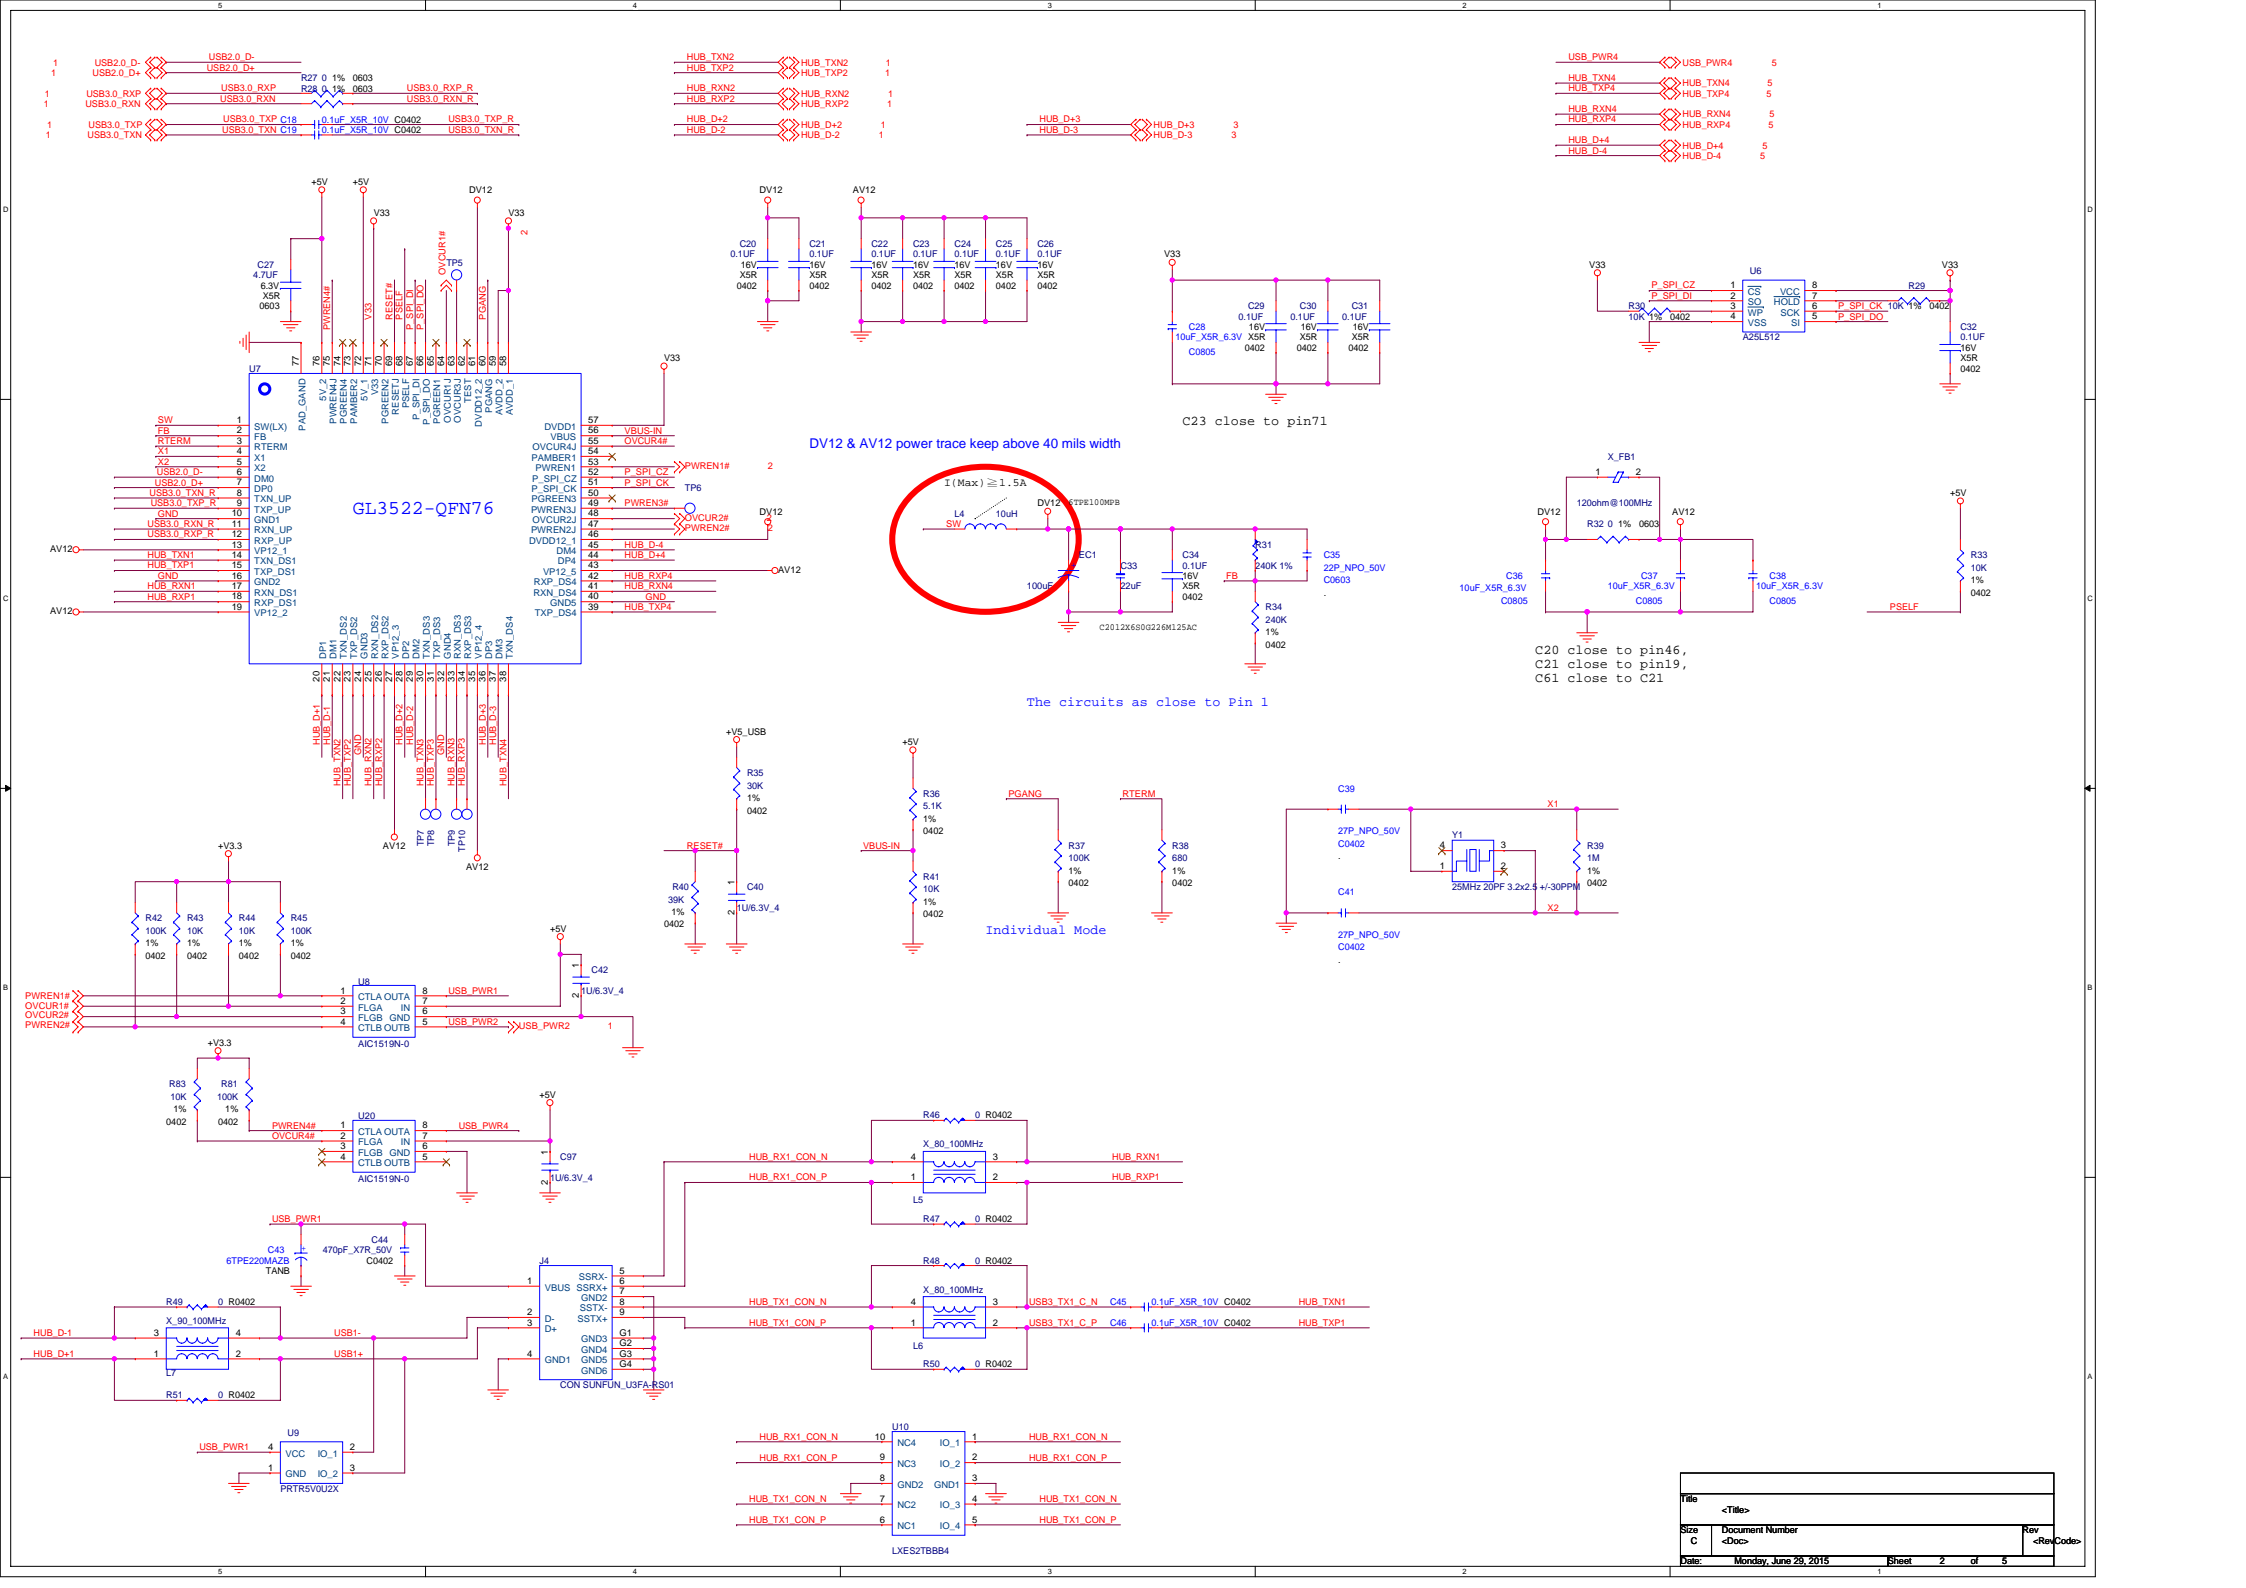
Use 250mils wide trace bridging  
AGND and DGND at codec.  
See design guide.

5.16V SUPPLY 3A

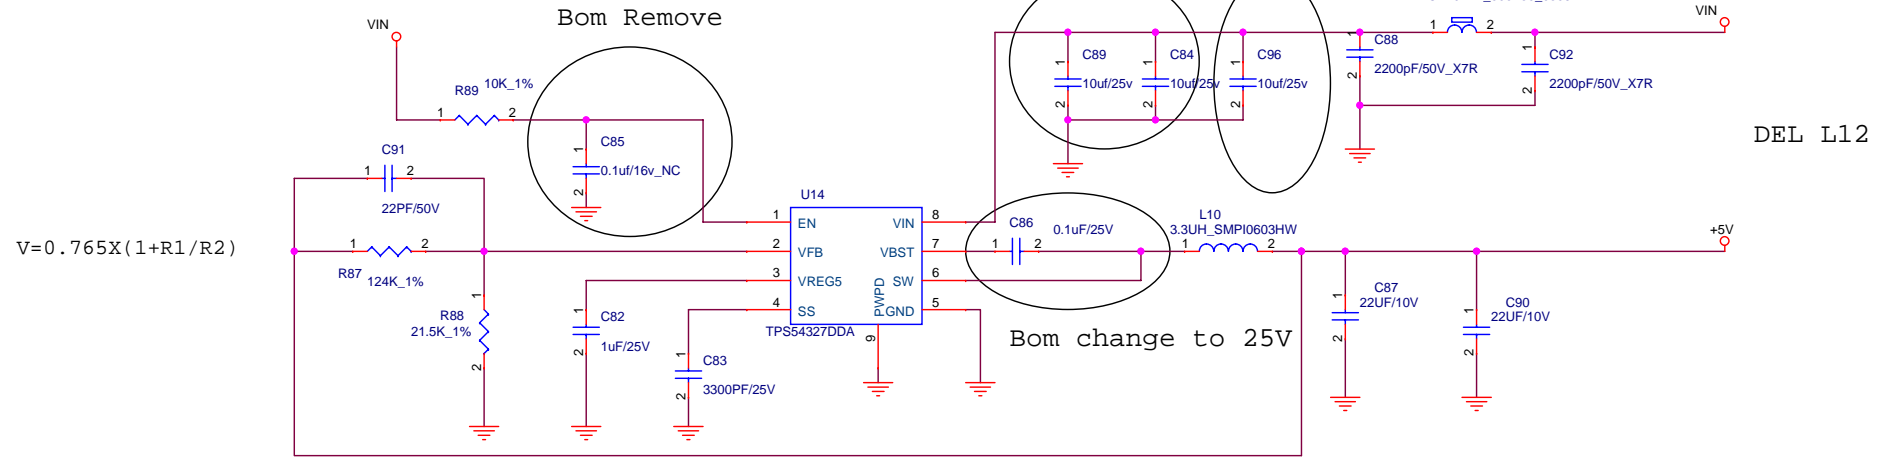
Change Package to 1206 and add 10UF/25V
